DUANE AND LAURA GRANT TRANSFERS

Via Brockway engineering they have filed 4 transfers basically all interrelated in one fashion or another. As of this date not all transfers have been data entered. The major goal is to have better priority rights associated with the current 155 acres now covered by 36-7267. Transfer 74404 and T-#2 should be processed together and T-#3 & #4 should be processed together. The rights after the splits for the first 2 transfers will be associated rights for the other 2 transfers. See last page for overview layout.

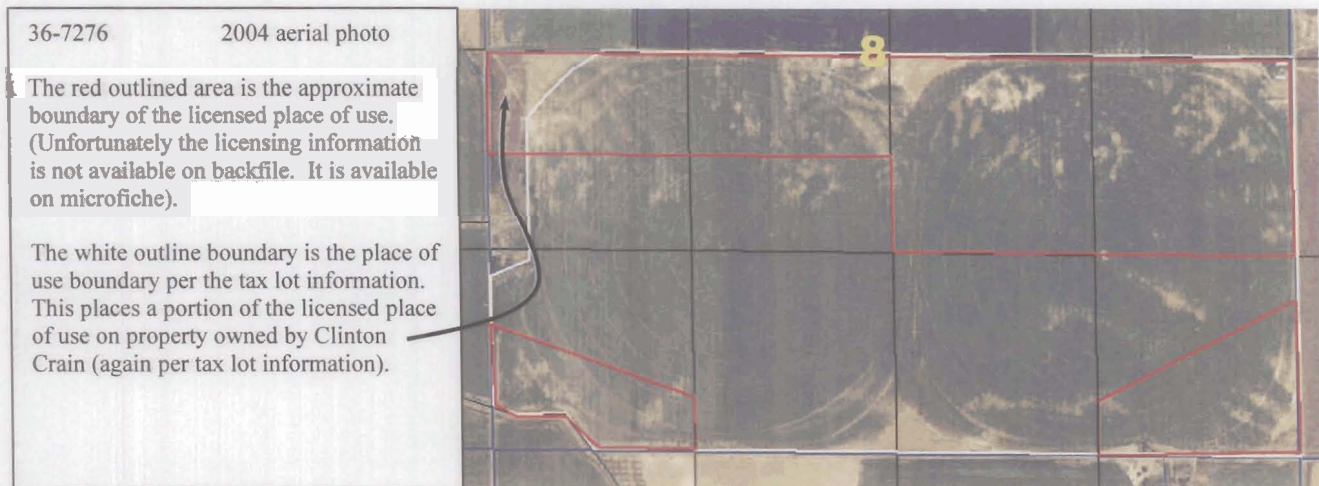
2. The to POU is identified on our system as a nominal shape but the field exam notes for licensing show a shape that I basically duplicated in the map below. How much weight does the licensing field exam shape carry when defining the irrigated place of use for a right? And, does a change in that area then require a transfer, specifically in this case the change of ownership identifies both parties as being associated with the field exam shape. The licensed shape includes ground not owned by Grant and Zach (for Brockway) is in the process of obtaining a quit claim deed for that portion. This would necessitate a change in the place of use for 36-7267 assuming that the field exam shape drives the actual POU. Does this right need to be included in the transfer as a primary right and fees calculated for this portion also? I assume that we cannot go with a nominal POU shape when they are identifying specific acres basically as licensed.

3. As T-74404 brings in 16.1 acres to be recognized within the 155 acre PPU that 16.1 acres are being transferred out via transfer # 2 do we have to have the applicant identify 16.1 specific acres that will disappear through the approval of the 155 acre PPU?

4. As you can see the current system for 36-7267 is two center pivots. A&B provides water for the ground not covered under this license. The theory is that they are independent of each other, although the combination of shares and licensed acres would suggest some overlap. They do not want to pursue a PPU of the ≈ 304 irrigated acres because they are afraid that A&B will object to overlapping POUs. (This really doesn't make sense because that is the reality. A paper issue I guess)

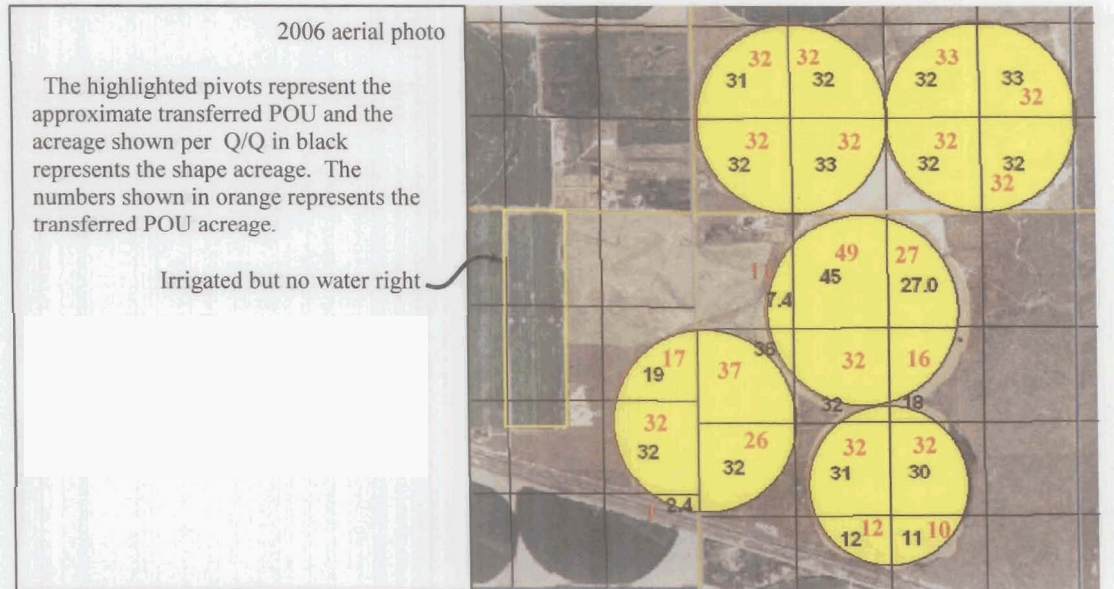
1. The from POU issues are discussed above.
2. The to POU is identified by Brockway as adding 16.1 acres to the 299 acre limit within the 591 acre PPU. This is inaccurate from about any way you look at it.

3. Our spatial data shows two POU shapes at the to POU. Both are wrong.
4. The to POU per T-5282 is identified as 584 irrigated acres within a 591 PPU. Per the 2004 and 2006 aerial photos Grant is irrigating approximately 612 acres via the pivot system and another 60 acres in Sec 1 W $\frac{1}{2}$ E $\frac{1}{2}$. As the differences are generally in the range of 1 to 2 acres per Q/Q do we want to address this or just let it slide? There is also the issue of 7 additional irrigated acres above the 584 acre limit. This appears to be primarily associated with end gun use associated with the center pivot.

5. The application indicates that the 16.1 acres are to be added to the total irrigation limit associated with the 591 acre PPU. They identified is as 299 ac limit + 16.1 acres giving a total acre limit of 315.1 irrigated acres within the 591 acres. Apparently Brockway missed T-5282 that identifies the POU as 584 irrigated acres within the 591 acre PPU. By adding 16.1 acres to the irrigation limit you get 601.1 acres within the 591 acre PPU. How far should we go in offering suggestions to the applicants/representatives as to alternative methods of structuring an application for transfer?

From Brockway transfer application. POU for 36-2198 and 36-2199

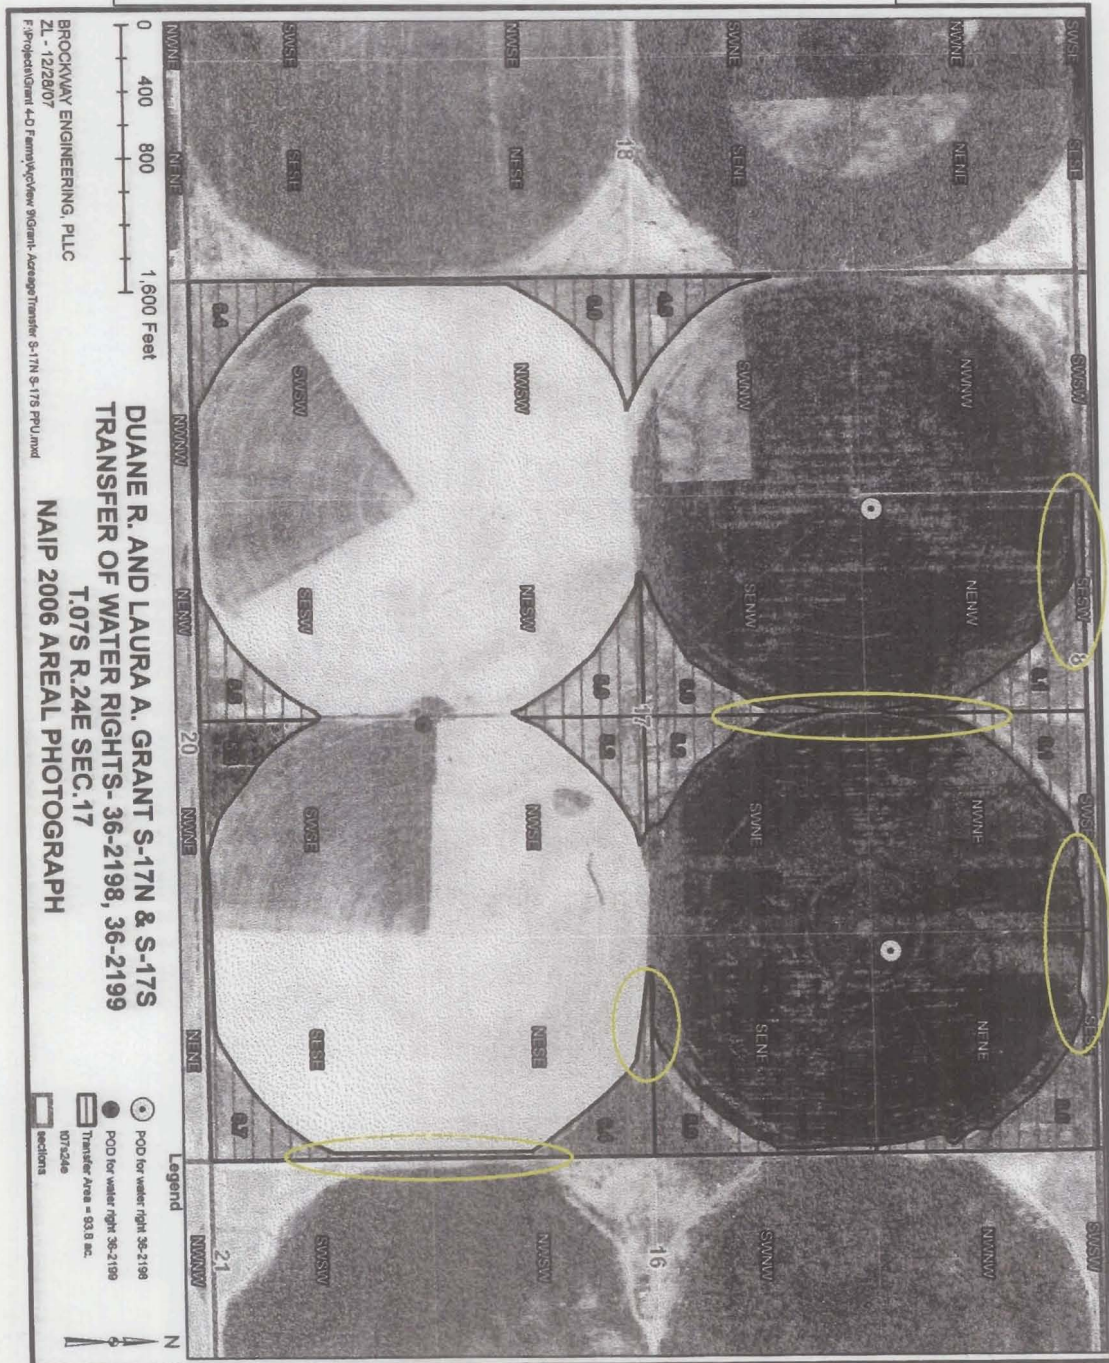
1. The transfer proposes to move the 93.8 acres from the 155 acre PPU to the corners associated with the two rights. As laid out by the transfer if there were a priority cut requiring the corner shapes to be left dry, the current pivot system would actually irrigate a portion of the ground designated as dry. Do we want to go to this detail in reviewing pivot corners?

Areas likely unable to dry up if required. Identified within the yellow boundary.
